Responses to Recommendations from AAC 2018

compiled by Peter H. Garbincius – October 29, 2019

GARD-SRF Roadmap: High Q₀ Frontier

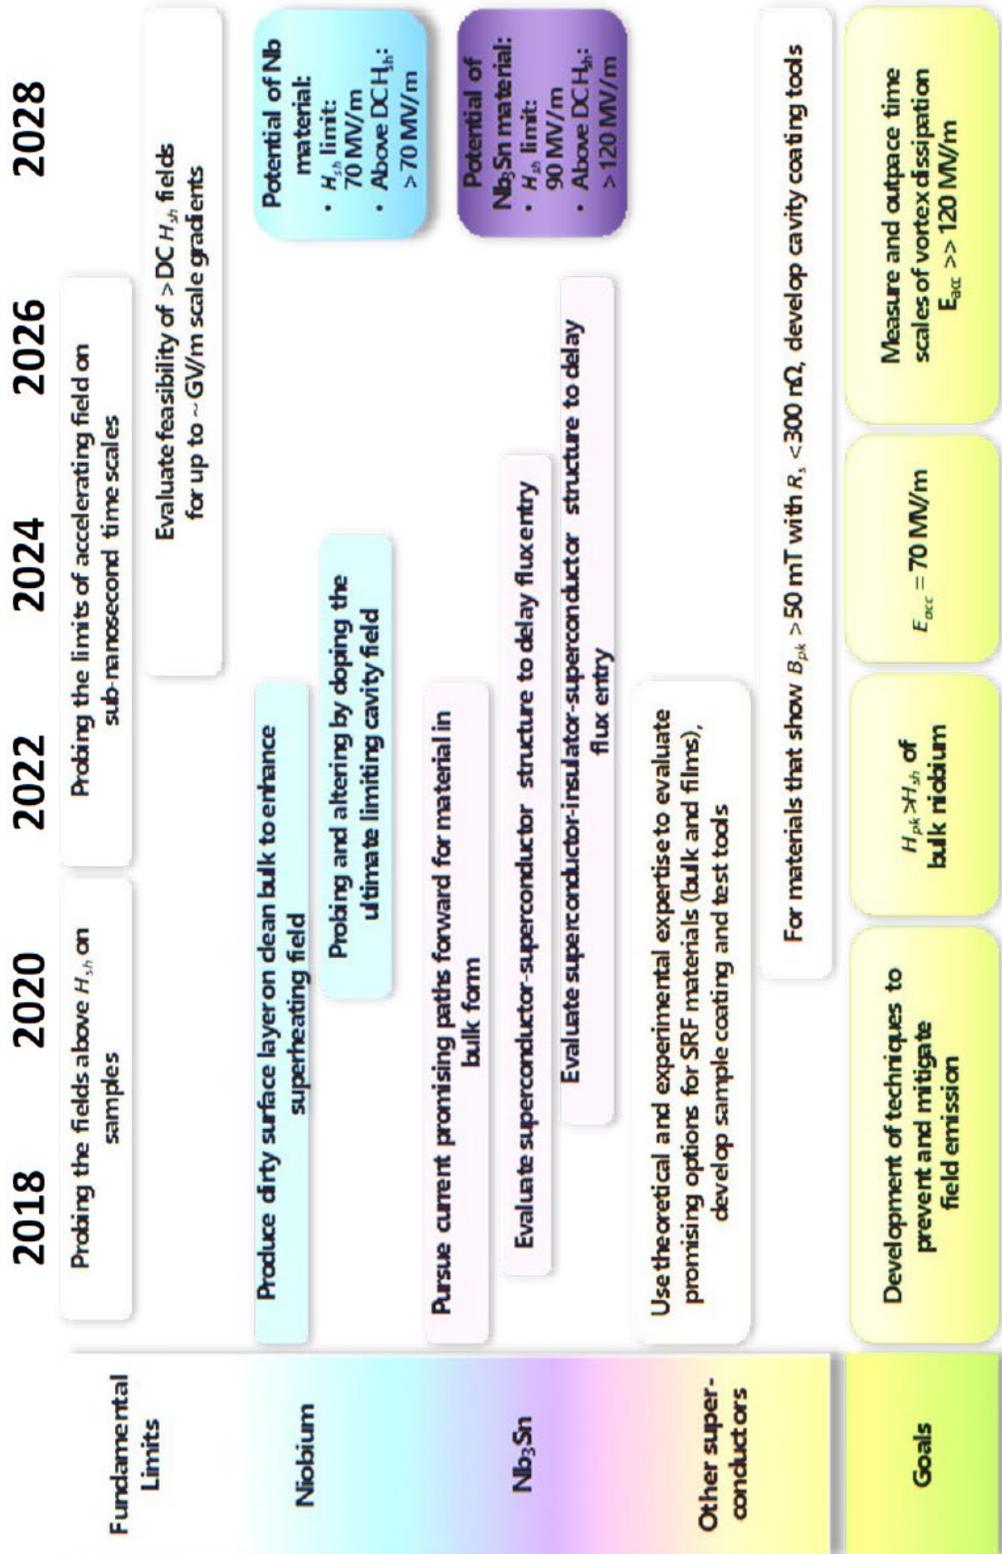
- Fermilab’s SRF groups have made impressive contributions to projects around the country and the goals generally aligned with future machines. Develop a multi-year FNAL SRF technology development plan that aligns with the HEP roadmaps and includes FNAL priorities and QIS initiatives. This will help to clarify your priorities internally and externally.

Currently, our program follows the GARD-SRF Roadmap, which was developed with substantial contributions from Fermilab. Fermilab also hosted the GARD-SRF Roadmap Workshop in 2017 that brought in SRF researchers from US labs and around the world to help develop the most promising research directions for the next decade: <https://indico.fnal.gov/event/13606/> . The roadmaps for the High Q_0 and High Gradient Frontiers are reproduced below.
